DESIGN ADVISORY BOARD Tuesday, August 12, 2014 Conference Room 12, City Hall, Burlington, VT AGENDA

MEMORANDUM

To: The Design Advisory Board
From: Mary O'Neil, AICP, Senior Planner *MO*
RE: ZP 15-0079CA; 281 Flynn Avenue
Date: August 12, 2014

TO: Design Advisory Board
FROM: Scott Gustin *SG*
DATE: August 12, 2014
RE: 15-0055CA, 15 Conger Avenue

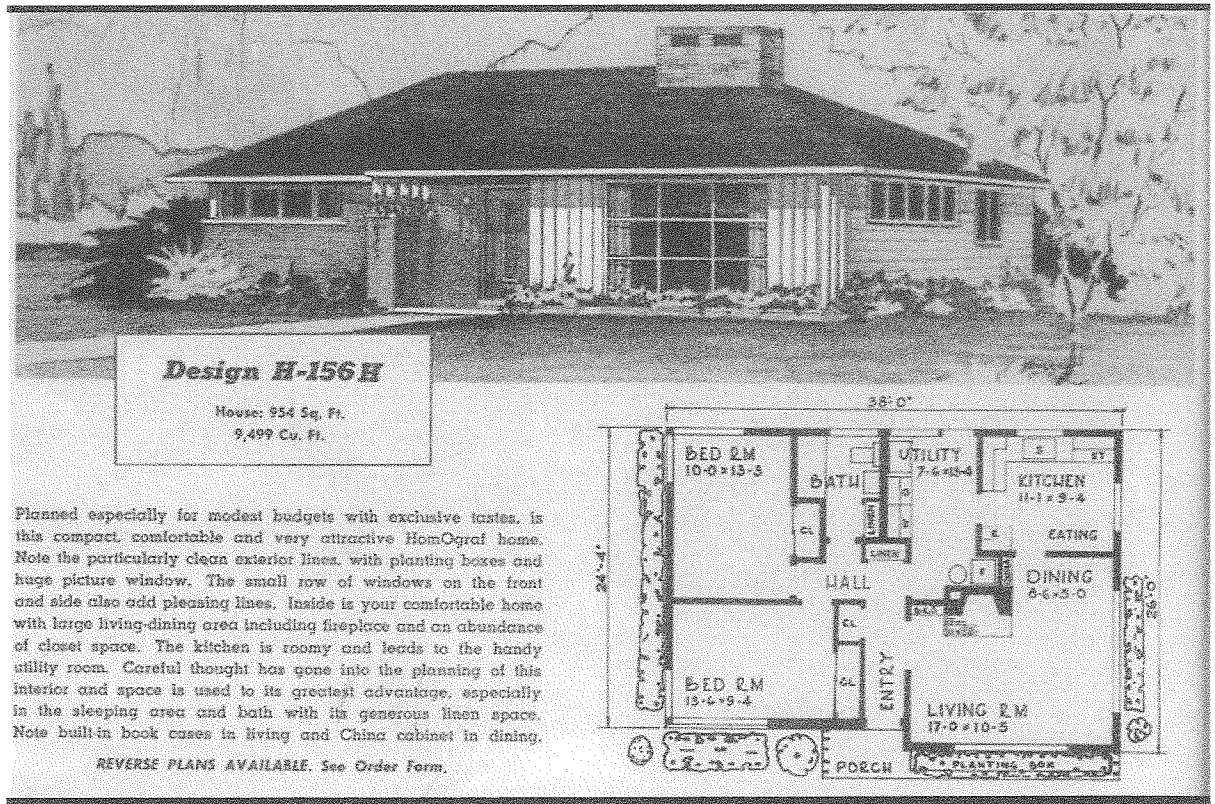
This is a typical plan, this one from Gordon-Van Tine, illustrating the 26' x 32' single story mass with hipped roof. Note the off-set front door, which is replicated at 281 Flynn Avenue.

Even the footprint (32' x 26') reflects its heritage among building plans popular in the decades prior to its construction date. Some plans had centralized entry doors, but others showed a

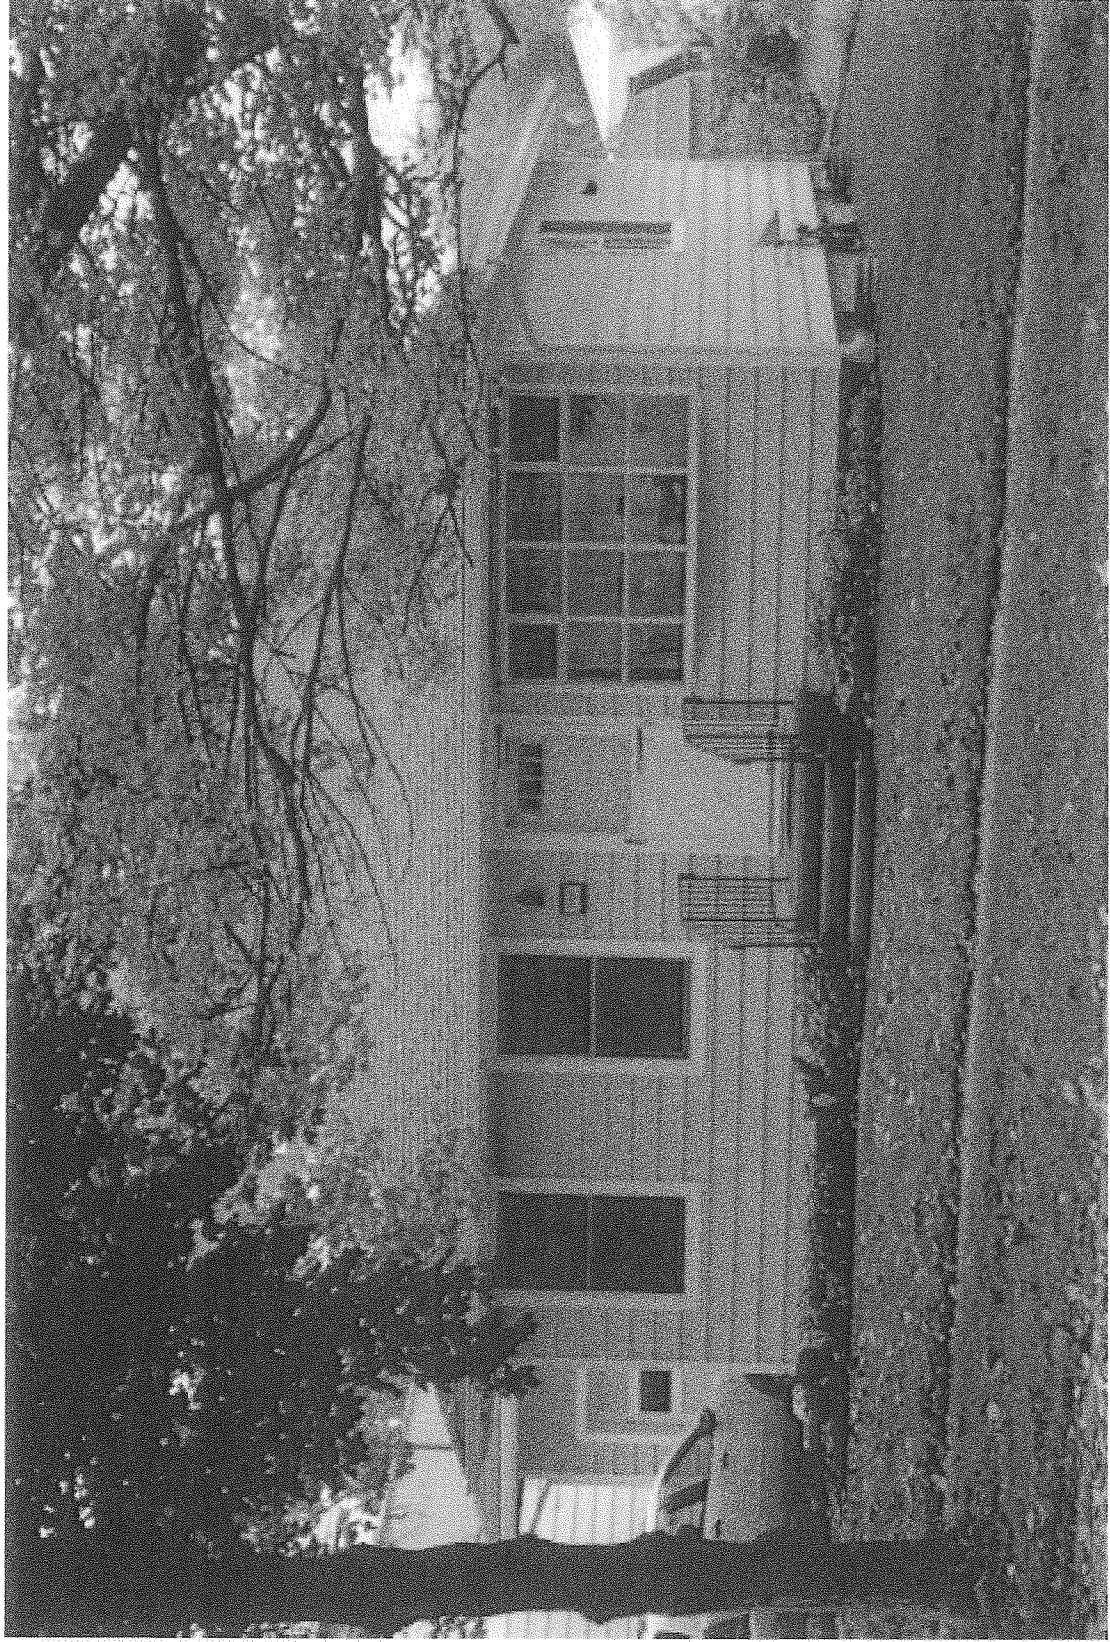
No changes are proposed to the existing yard, landscaping or fences is included within this application. Although the submitted site plan isolates the square footage for the deck, the deck has already been approved. See background (above) for a list of approved zoning permits for site amenities.

1 North Elevation

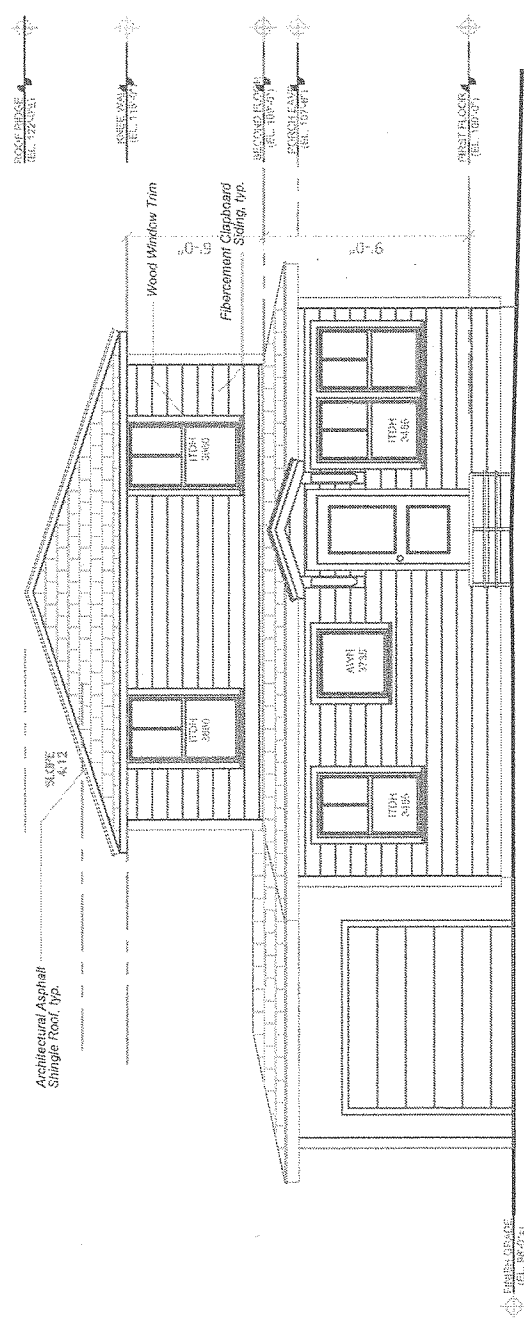
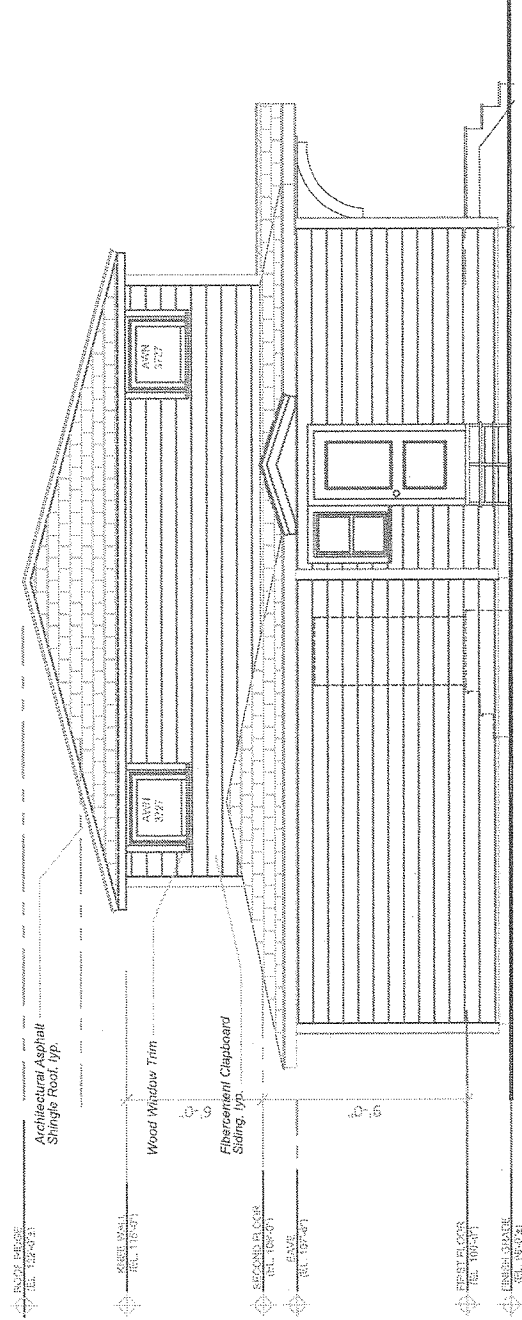
Design plans include canopies over both front and side entrances to protect residents from inclement weather. The rear elevation appears to illustrate a small eave overhang that would provide a minimal amount of cover when the sliding door is utilized.

There exist double hung windows, a multi-pane bow window, and a sliding door in the rear. The development proposal includes paired double hungs installed on the north elevation to replace the bow, a smaller window to accommodate a kitchen installation, smaller windows on the upper floor of the east elevation and similar windows on the south and west. The entrance doors on the front and east are proposed to remain in the same location.
